ADDENDUM #1

Reference: Utility Tunnel Expansion – Redwood Road Campus
Salt Lake Community College – Salt Lake City, Utah
DFCM Project No. 06163660

Addendum No. 1

Project:	Utility Tunnel Expansion - Redwood Road Campus	Date:	27 April 2006
Address:	4600 South Redwood Road	Project No.:	0647.01
City, State:	Salt Lake City, Utah 84130-0808	Owner No.:	06163660
Owner:	DFCM	Agency:	Salt Lake Community College

1 LIGHT POLE BASE DETAIL
 AD-1 NO SCALE

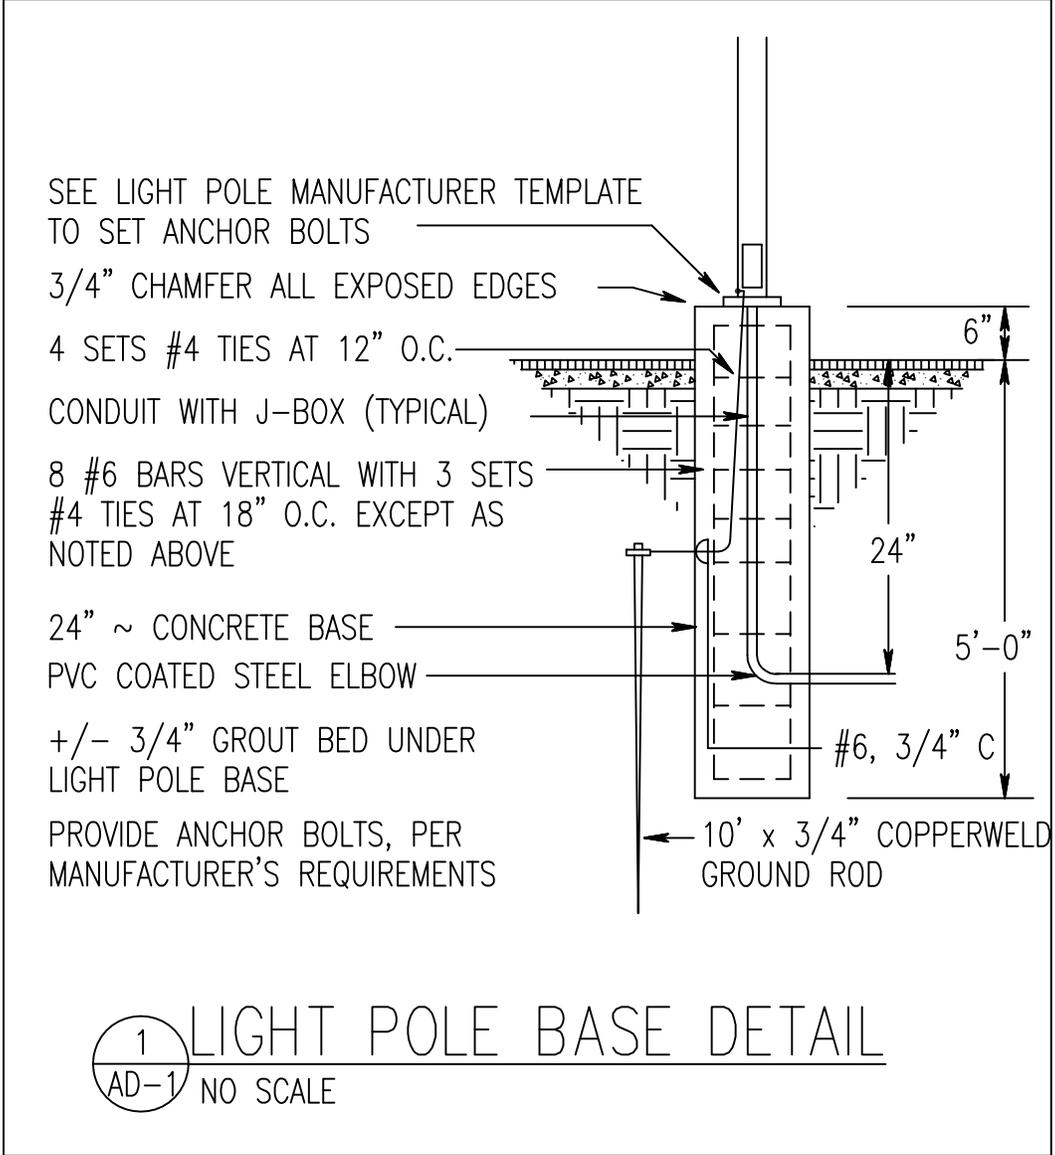
Item No.	Section or Sheet No.	Description
		Change title of detail to read: "CONCRETE SIDEWALK & DRIVEWAY JOINT DETAILS"
1 -23	AE501	Add the attached light pole base detail, (1/AD-1) to this page.
1 -24	AE501	Details C6, B6: Delete these details and replace with the following description: At the seven (7) sump pump locations - see ME101, provide a 24" round block out in the bottom of the precast tunnel sections. After the tunnel sections are set, hand excavate at these locations to allow placing 18" dia. X 30" deep (I.D.) Water meter boxes. Pour 6" floor in the bottom of the water meter box, and grout at top to form tight seal with the tunnel section. Provide 18"X18" metal bar grate with frame - all hot dip galvanized and place frame in topping slab.
1 -25	ME101	At the southeast corner of the tunnel, at the floor sink location, extend the 3" drain line approximately 10'-0" south and tie into the top half of the existing 8" sanitary sewer. The elevation of the line is approximately the bottom of the tunnel.

2 JOINTS AT PRECAST SECTIONS
 AD-1 3"=1'-0"

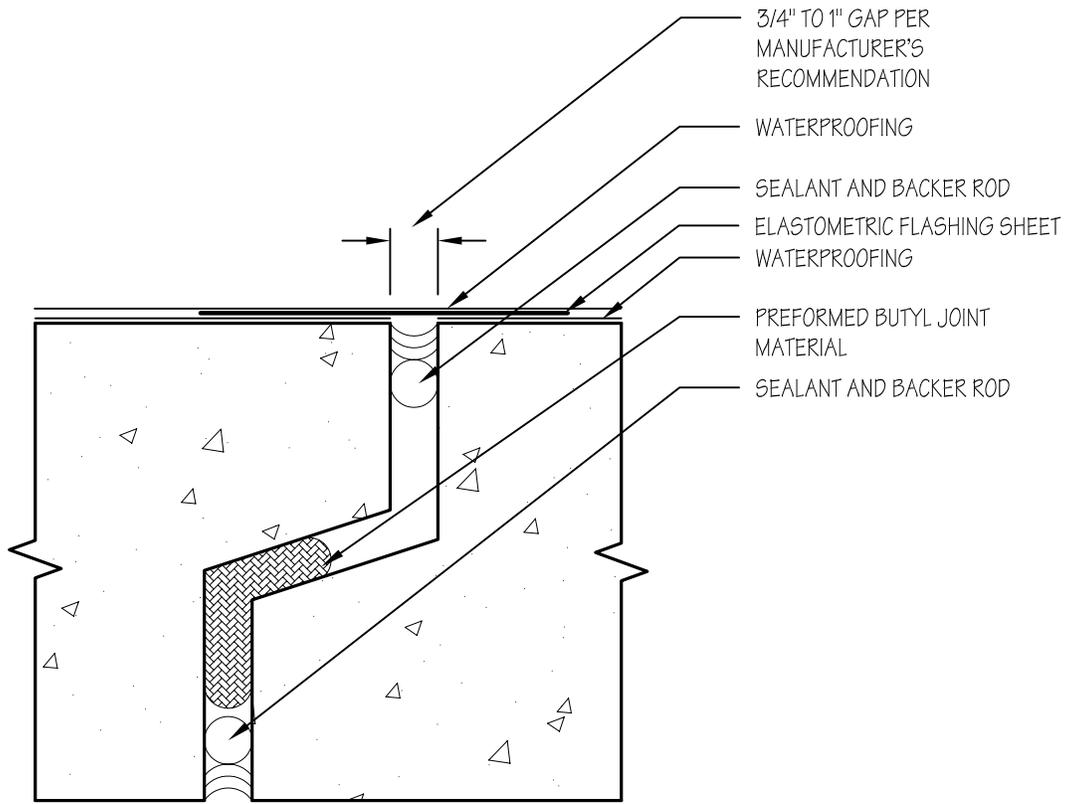
1 -26	MH401	Replace drawing with the attached MH401.
1 -27	MH402	Replace drawing with the attached MH402.
1 -28	MH403	Replace drawing with the attached MH403.
Prior Approvals:		
1 -29	Protecto Wrap	by Daly & Associates, not approved.
Attachments:		
1 -30	1/AD-1	Light Pole Base Detail, 1 page.
1 -31	2/AD-1	Joint at Precast Sections Details, 1 page.
1 -32	Mech. Add. 1	6 pages (4 drawings).
1 -33	Elec. Add. 1	2 pages.

SHEET TITLE
**MECHANICAL
 DEMOLITION SITE
 PLAN**
MD101
 SHEET 18 OF 27

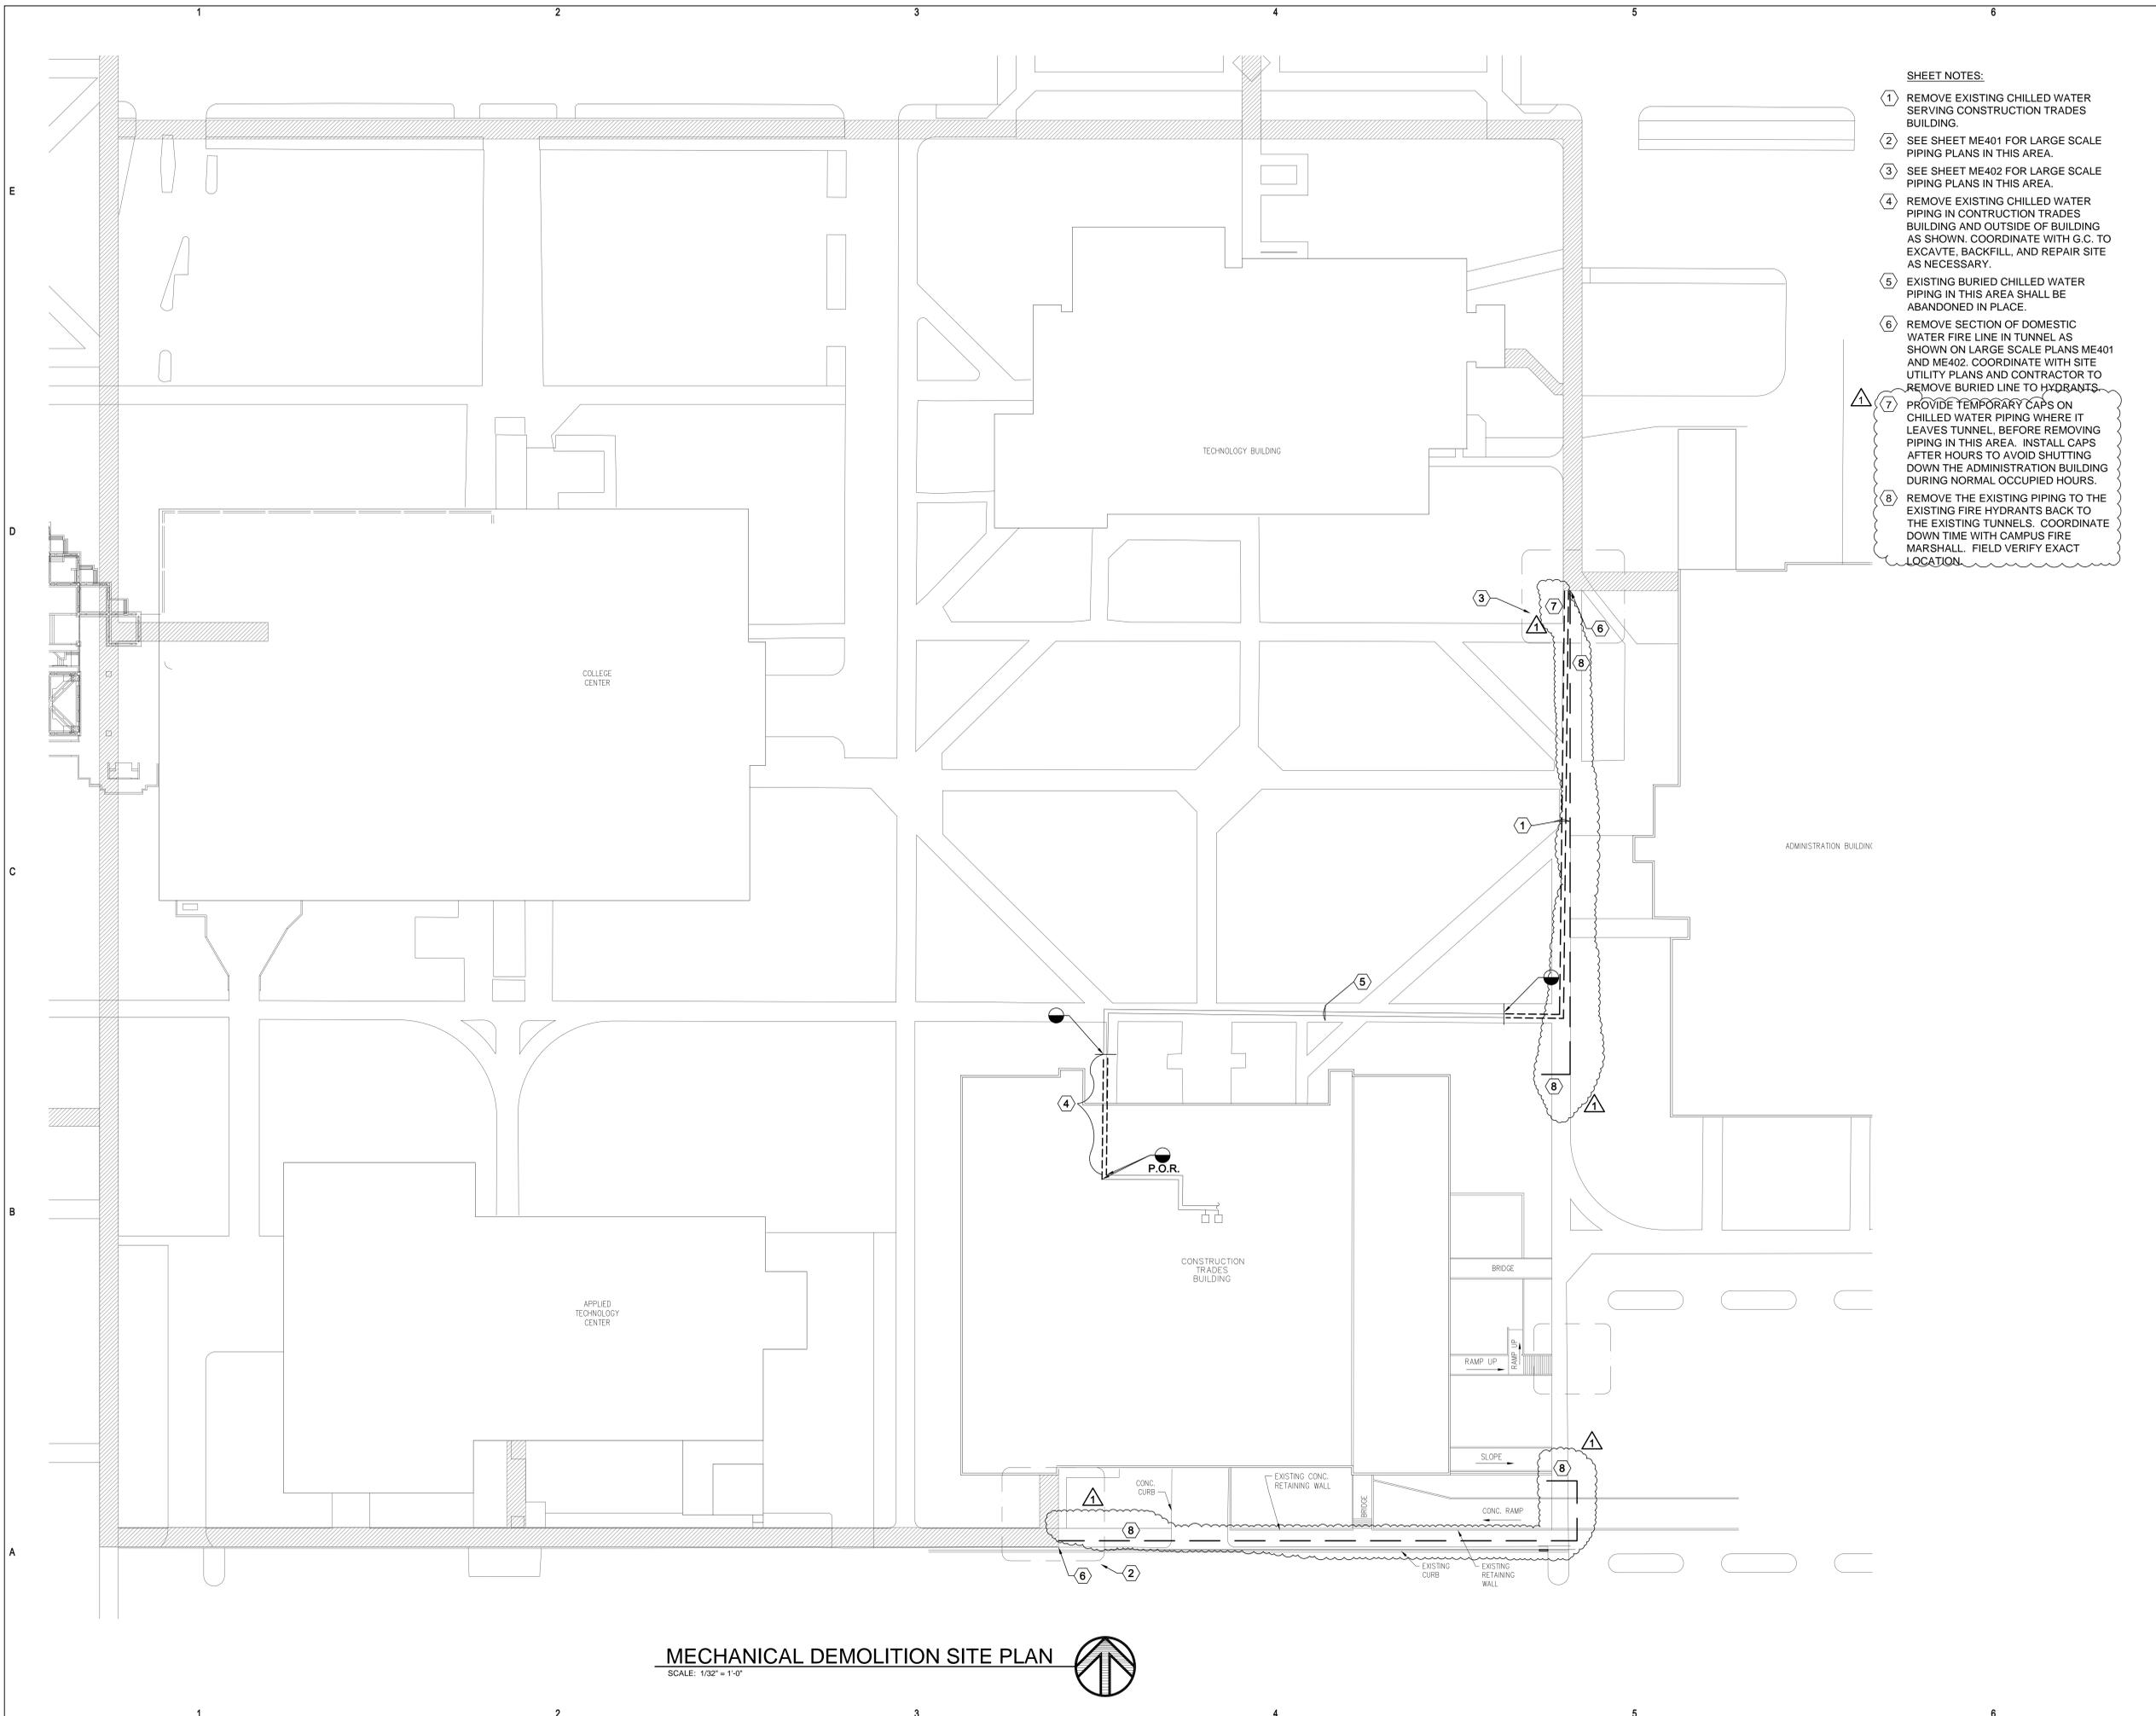
Item III-1. Sheet MD101 and Sheet ME402 - A1/ADMIN BUILDING TUNNEL PIPING DEMOLITION PLAN: The two butterfly valves shown south of the admin piping branches, just before the chilled water piping leaves the tunnel do not exist, and will not be installed in a previous contract. When it is time to remove the buried chilled water piping shown on sheet MD101, it will be this contractor's responsibility to provide a temporary means to cap this piping when the buried pipe is removed. The valves upstream of the admin building take-offs will be able isolate this section of pipe while installing the temporary caps. The temporary caps will need to be installed after hours, so that the admin building will not be without cooling during normal business hours.

Item III-2. Sheet MD101: Added the demolition of existing fire lines that run in the path of the new tunnel.

SCALE 1/16" = 1'-0"		DATE 04/26/2007
DRAWN BNA	CHECKED RW	SHEET NUMBER
JOB NUMBER 07015A		ESD-1
REF. SHEET NUMBER E100

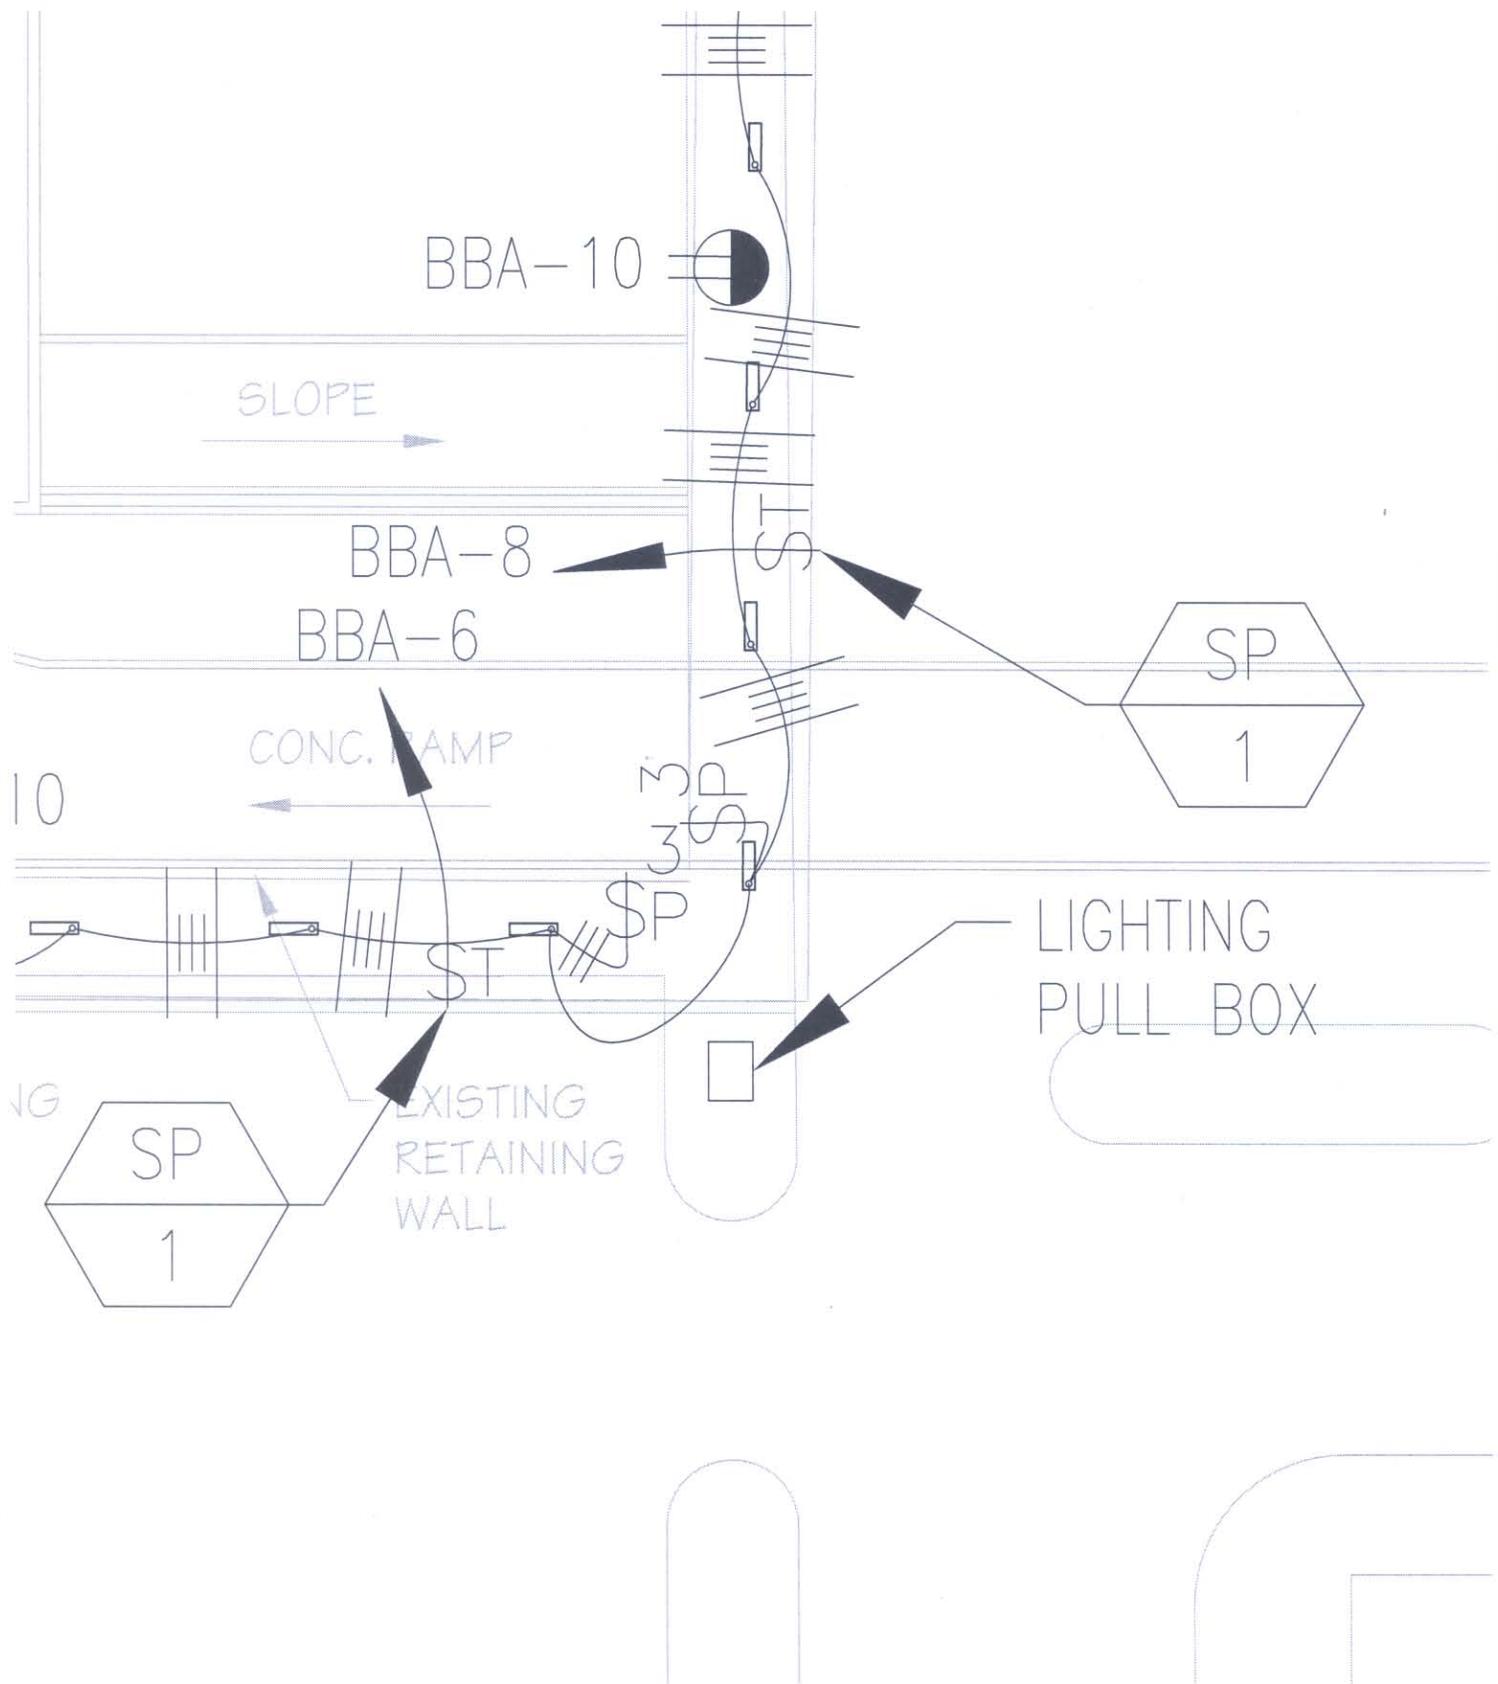
1. The electrical contractor shall locate and protect the four (4) conduits that route through the lighting pull box (see attached drawing ESD-1). The two circuits that route through the box shall be maintained during the duration of the project. Contractor shall provide all necessary materials and labor.
